## **DEVELOPMENT REVIEW COMMITTEE (DRC) COMMENT REPORT**

**Project Name:** Davie Blvd Office, LLC / Davie Boulevard Office Building

**Case Number:** R15019

**Request:** Site Plan Level II Review: 7,239sf Office

# RECORD LAND SURVEY

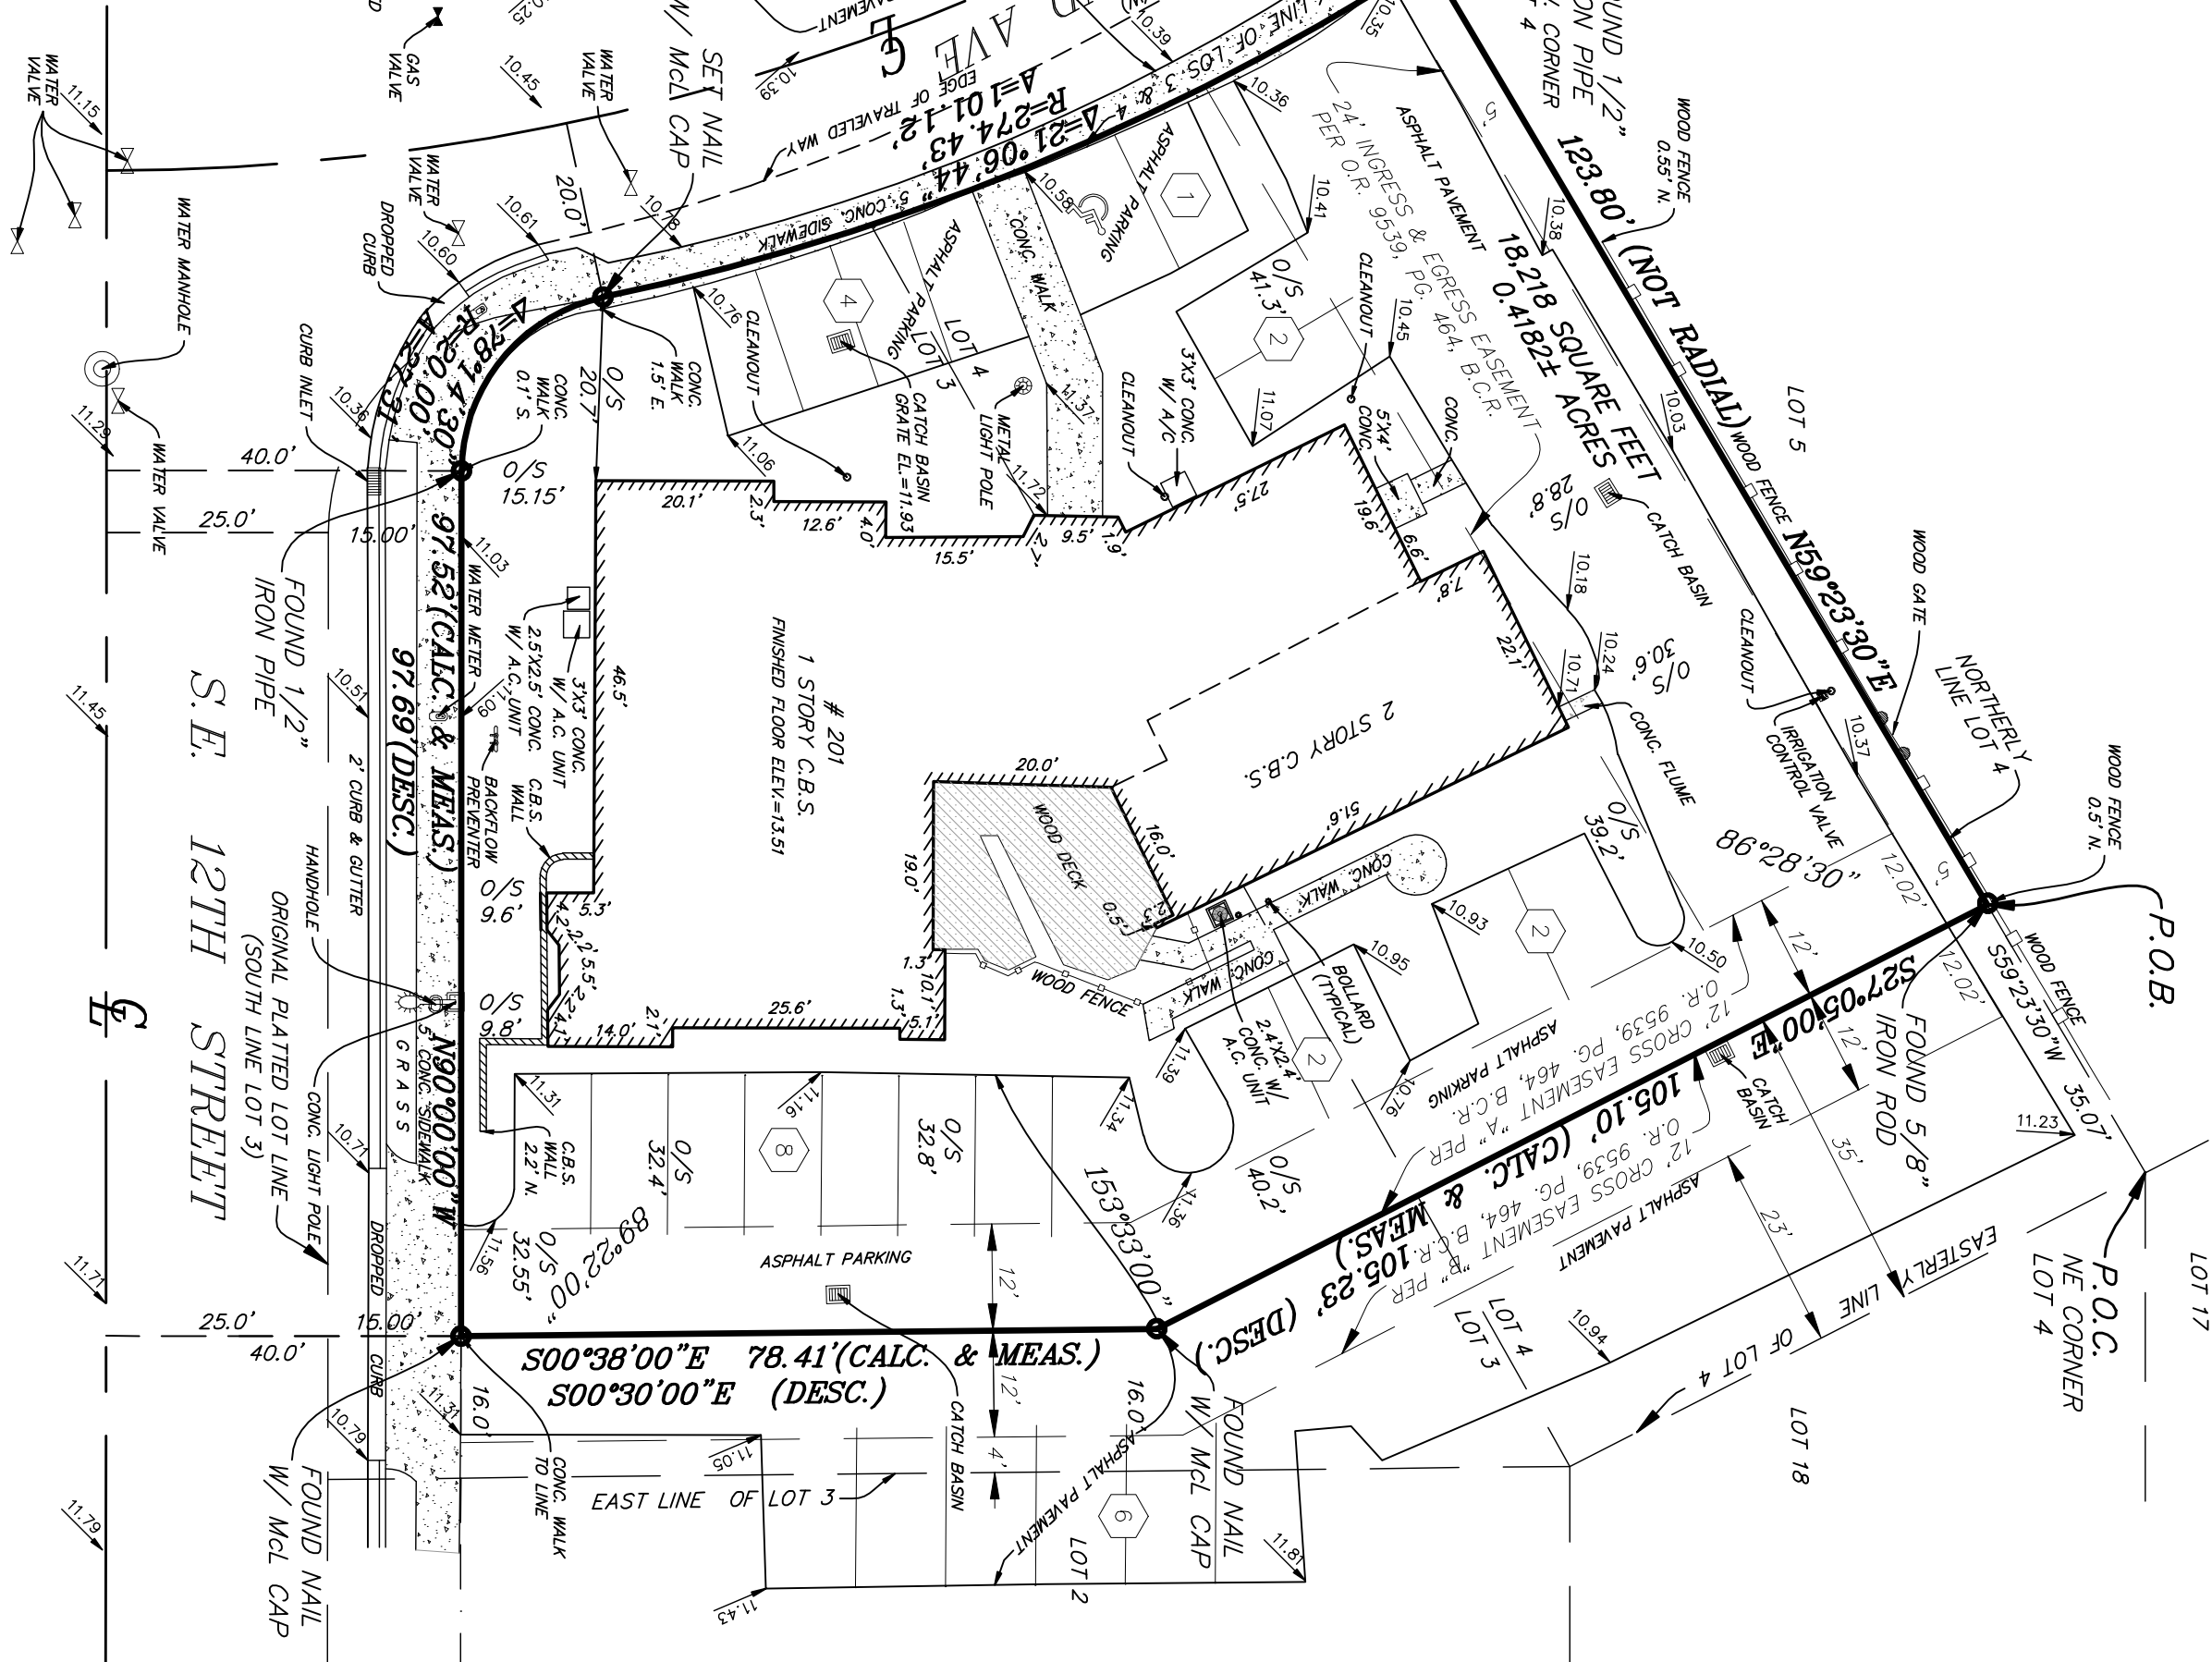
- c. Maintenance Agreement Area Exhibit
  - d. Revocable License Area Exhibit
16. Submit a signed and sealed survey showing all above ground improvements, utilities, rights of way dimensions and all easements. This survey shall be based on an a Standard Title Commitment issued by a title insurer licensed to do business in Florida or an Opinion of Title issued by an attorney admitted to the Florida Bar. The title commitment or Opinion of Title must have an effective date no more than thirty days prior to the date of submittal of the survey and must be certified to the City of Fort Lauderdale. Additionally, an affidavit shall be provided by the property owner attesting that there were no additional recordings of easements or encroachments from survey date to the final DRC sign off date.

25. Verify the existing utilities shown on the survey and describe whether the connection and routing of franchised utilities (power, cable, gas, communications, etc.) serving the proposed development will need to be removed and/or relocated.
